Jones Gillam Renz Architects

Irving Lofts – Historic Rehabilitation – JGR Proj 25-3479

ADDENDUM NO. 1

AA2.2

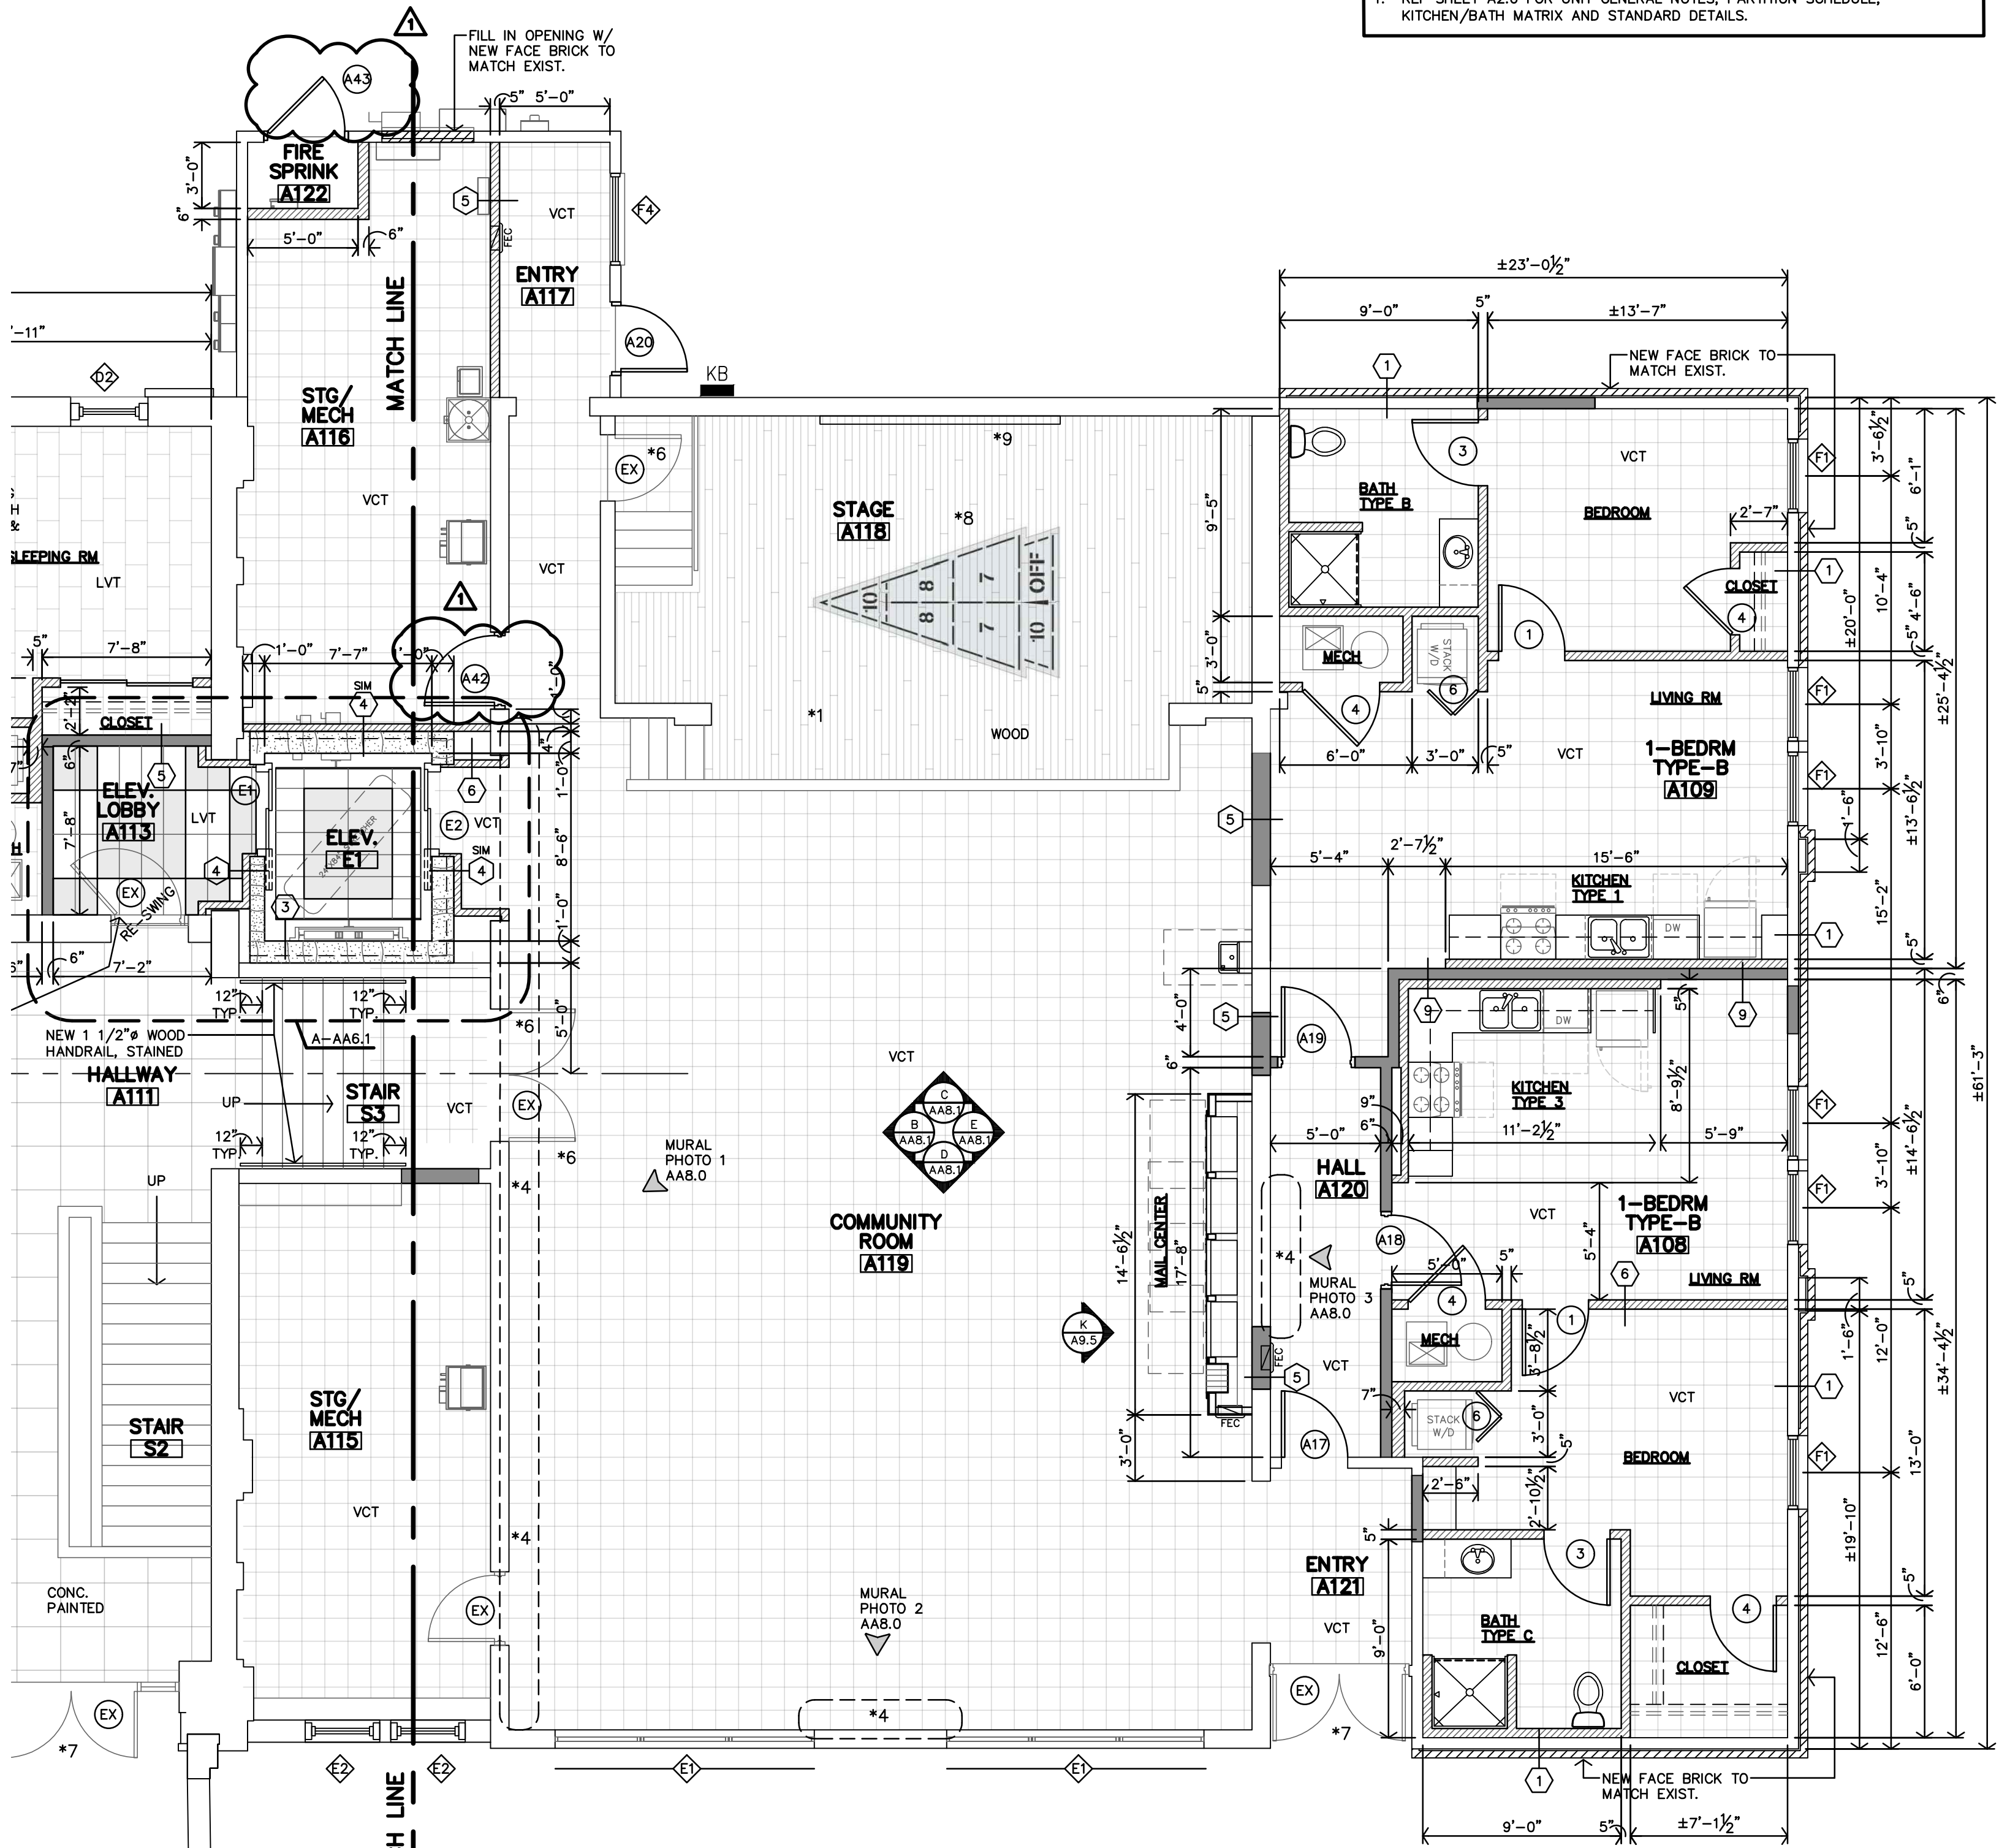
4. AA2.1 – Building A: Designations for Doors A41 & A44 have been revised (formerly doors A21 & A24) to avoid duplication of second floor door labels.
5. AA2.2 – Building A: Designations for Doors A42 & A43 have been revised (formerly doors A22 & A23) to avoid duplication of second floor door labels.

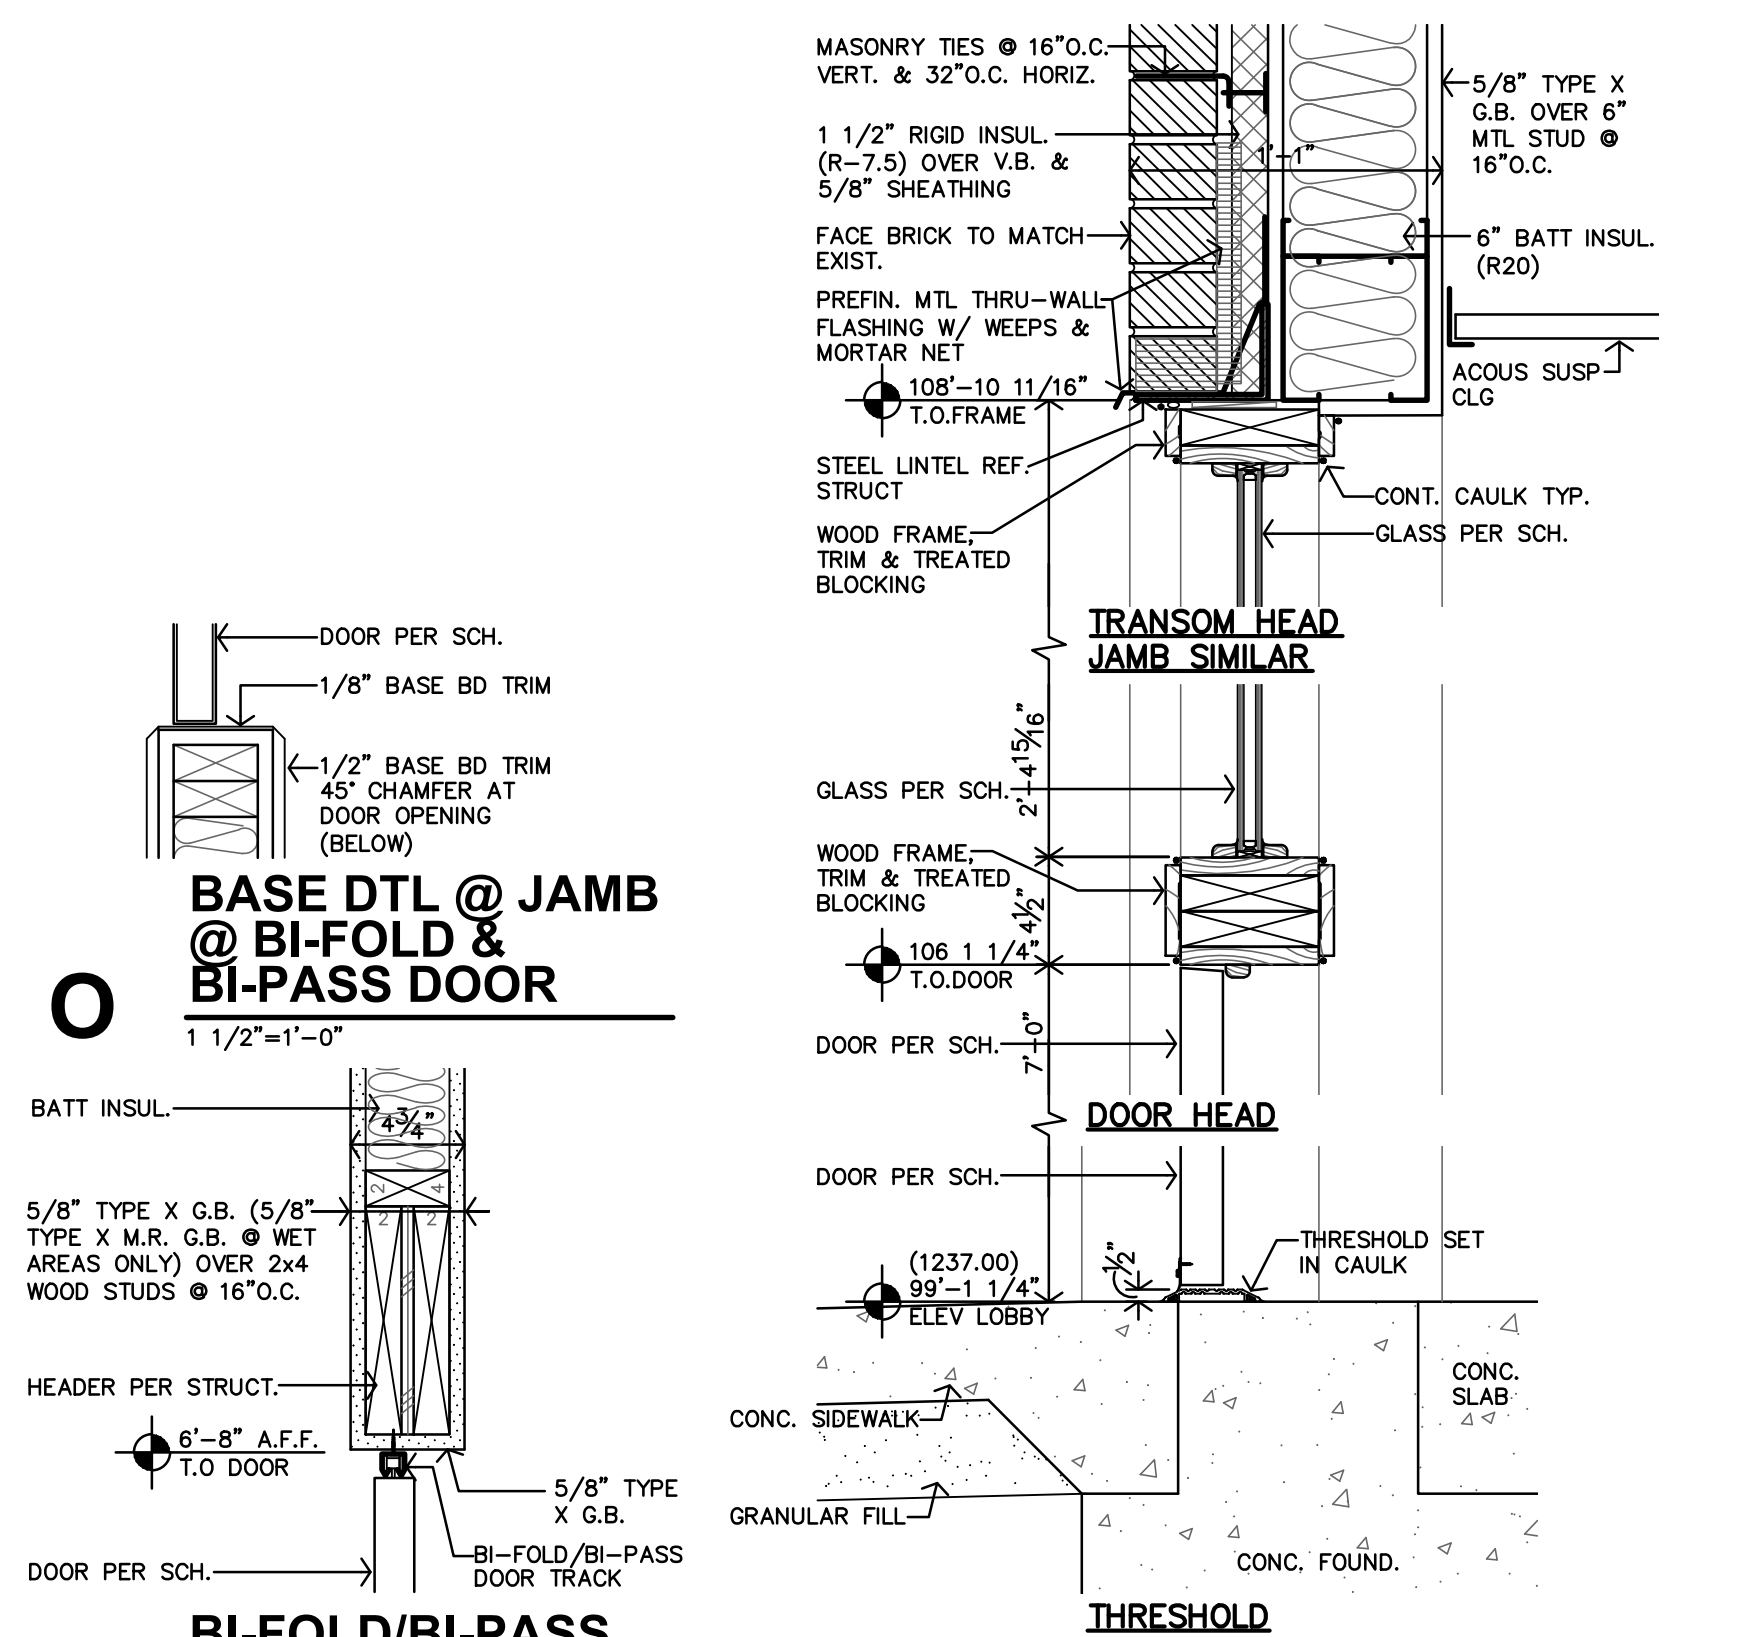
6. AA10.1 – Building A: Public Door Schedule – Select doors have been revised to 45 min. rated in lieu of 20 min. Door labels have been revised for first floor doors A41-44 (formerly A21-24) to avoid duplication of second floor door labels.
